CITY PLANNING COMMISSION

April 1, 2009 / Calendar No. 22

N 090239 ZRY

IN THE MATTER OF an application submitted by the Department of City Planning pursuant to Section 201 of the New York City Charter, for an amendment of the Zoning Resolution of the City of New York, relating to modifications of Article VI, Chapter 2 (Special Regulations Applying in the Waterfront Area) , and various related Sections of the Zoning Resolution.

ILLUSTRATION 1: UPLAND CONNECTION WITH ROADBED TURN

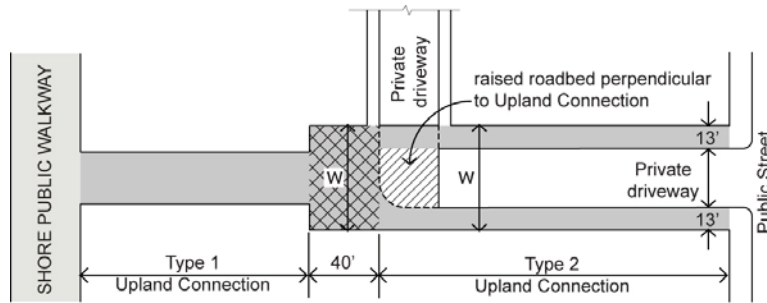
The existing requirements do not effectively address the transition between vehicular and pedestrian circulation areas within Type 2 upland connections, particularly at the end of an emergency vehicles access area. The proposed text would establish a “transition area” within the upland connection seaward of such vehicular turnaround or turn, which would extend 40 feet beyond the end of the roadbed, with a minimum width equal to the combined width of the roadbed and the Type 2 upland connection.

Additional design requirements would be established for the “transition area” to increase pedestrian/vehicular safety and increase the permeable surface in this largely paved area. These requirements include that:

- the grade level of the roadbed, within a turnaround or turning area, must be raised to meet the grade level of the adjacent sidewalk, with bollards or other protective barriers installed at the roadbed edge (see illustration 1, below);
- asphalt pavement within a turnaround is limited to the width of the roadbed leading to it, and the remaining paved area must be of a similar material to that of the adjoining pedestrian circulation path;
- forty percent of the transition area must be planted;
- a minimum of two shade trees or their equivalent in caliper inches of ornamental trees or multi-stemmed plants must be provided; and
- a minimum of 24 linear feet of seating must be provided.

ILLUSTRATION 3: MAXIMUM ZONING LOT DIMENSIONS TO WAIVE TRANSITION AREA

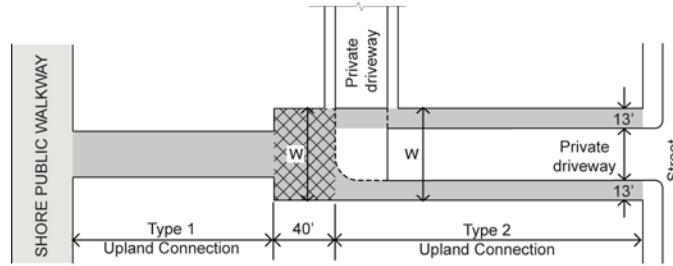
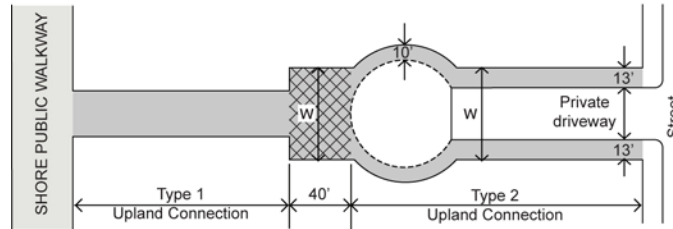
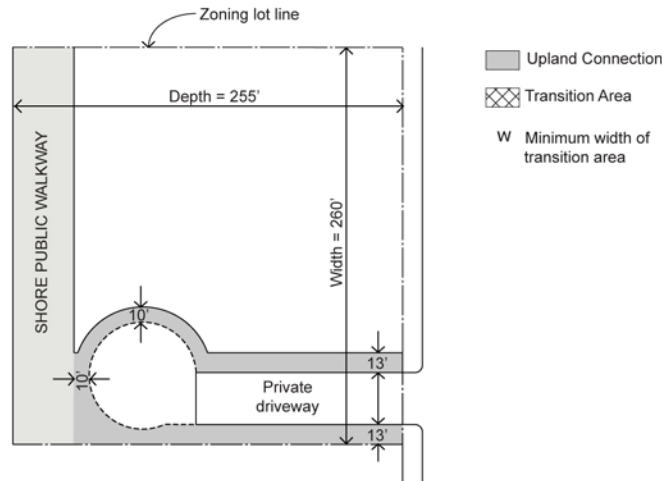
- (2) In addition, a “transition area” shall be provided which shall have a width equal to the combined width of the Type 2 #upland connection# and the roadbed, and shall extend for a distance of 40 feet measured from the termination of such roadbed in the direction of the #shore public walkway#, as shown in Illustrations 1 and 2 in this Section, for roadbeds that turn and roadbeds that terminate in a turn-around, respectively.

- (3) Such “transition area” is not required for roadbeds that turn and are located within 15 feet of a #shore public walkway#, or for #waterfront zoning lots# that are less than 255 feet in depth and 260 feet in width. However, for #waterfront zoning lots# that are less than 255 feet in depth and 260 feet in width, an area of at least 10 feet in width shall be provided between the edge of the roadbed and the upland boundary of the #shore public walkway#, as shown in Illustration 3 of this Section.

- The Commission modified the rules for the “transition area.” When a Type 2 upland connection is provided (as sidewalks on either side of a roadbed within a private drive), a “transition area” is required on the seaward side and adjacent to the termination of the roadbed. Such “transition areas” must extend seaward for at least 40 feet. Planting, seating and trees are required amenities within such area. The Commission has modified Section 62-51(b) to waive the requirement of the “transition area” for zoning lots that are less than 255 feet in depth and less than 260 feet in width, in order to alleviate potential site planning constraints. However, in order to establish a safe buffer between the vehicular roadbed and the waterfront public access area, a smaller area that must extend seaward from the vehicular access area for at least 10 feet, with no specific design standards is required. In addition, no “transition areas” will be required when a private loop road turns, within 15 feet of a SPW.

ILLUSTRATION: TYPE 2 UPLAND CONNECTION

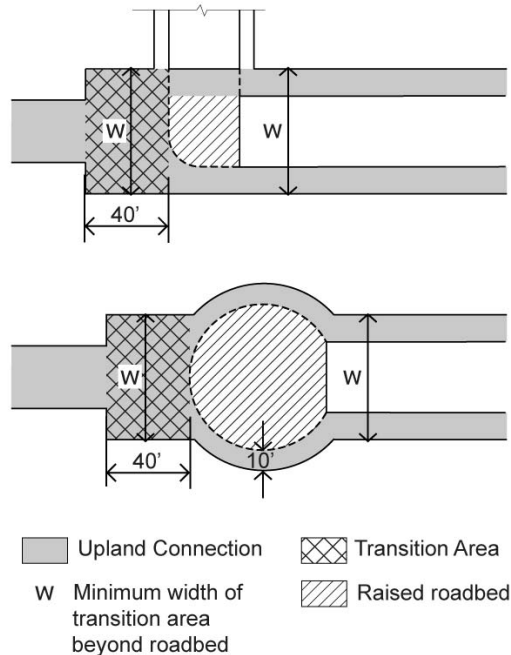
In addition, for Type 2 #upland connections#, the area of the roadbed between both circulation paths, within which lines perpendicular to the #upland connection# traversing the roadbed can be drawn or the portion of the roadbed within a vehicular turn-around, shall be raised to be flush with the level of such adjoining #upland connections# (see Illustration).

Illustration A1
(previous illustration deleted and replaced, above)

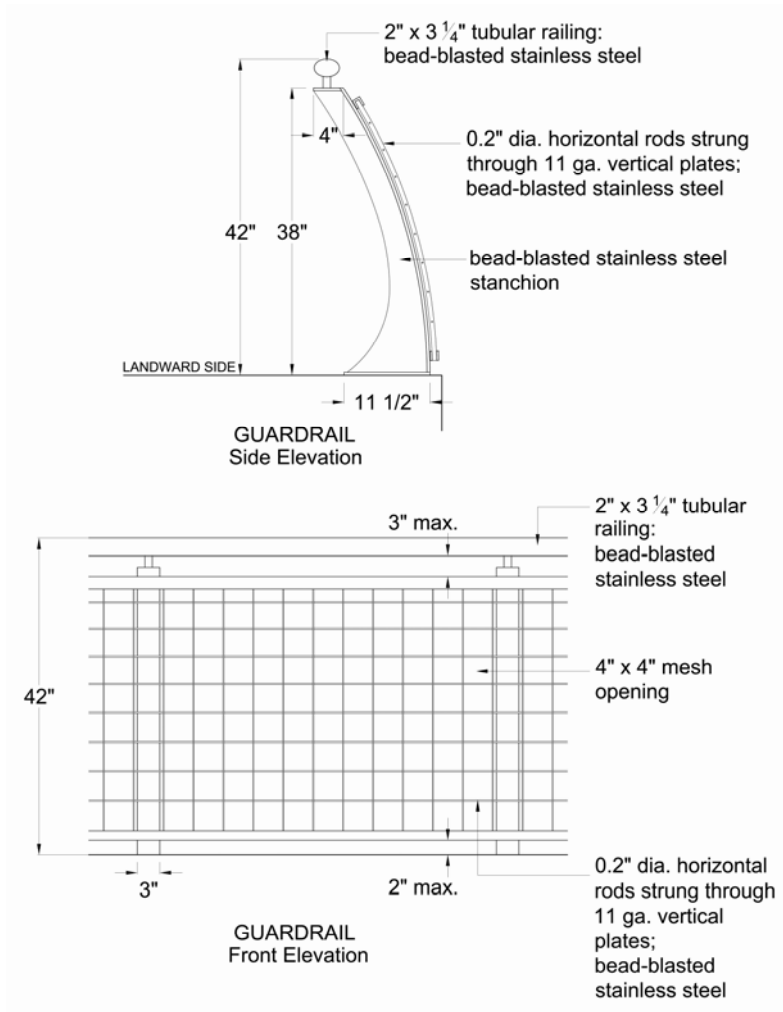
In addition to the provisions of paragraph (a) of Section 62-651 (Guardrails, gates and other protective barriers), guardrails shall comply with Illustration A1 of this Section.

Illustration B1
(previous illustration deleted and replaced, above)

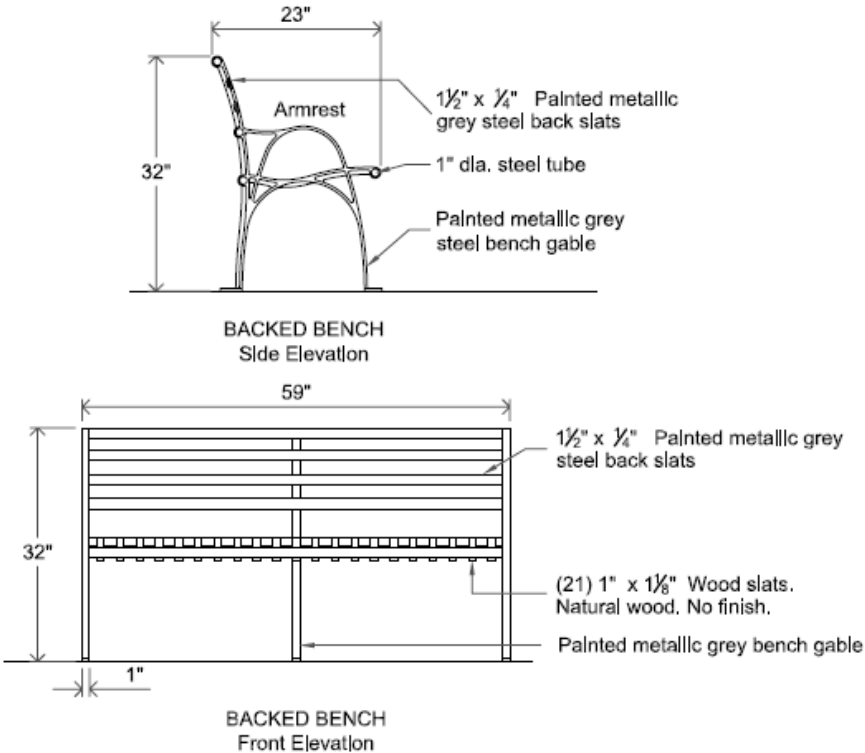
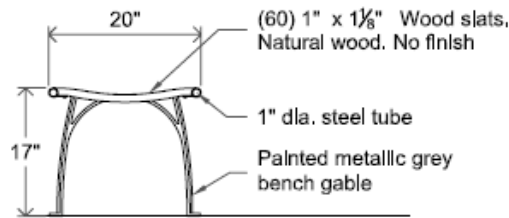
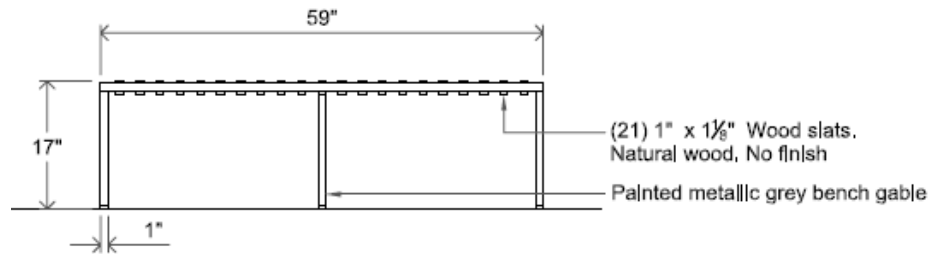
In addition to the provisions of Section ~~62-672~~ 62-652, at least 50 percent of the required seating along any #shore public walkway# or #supplemental public access area# shall comply with Illustration B1 or B2 in this Section.
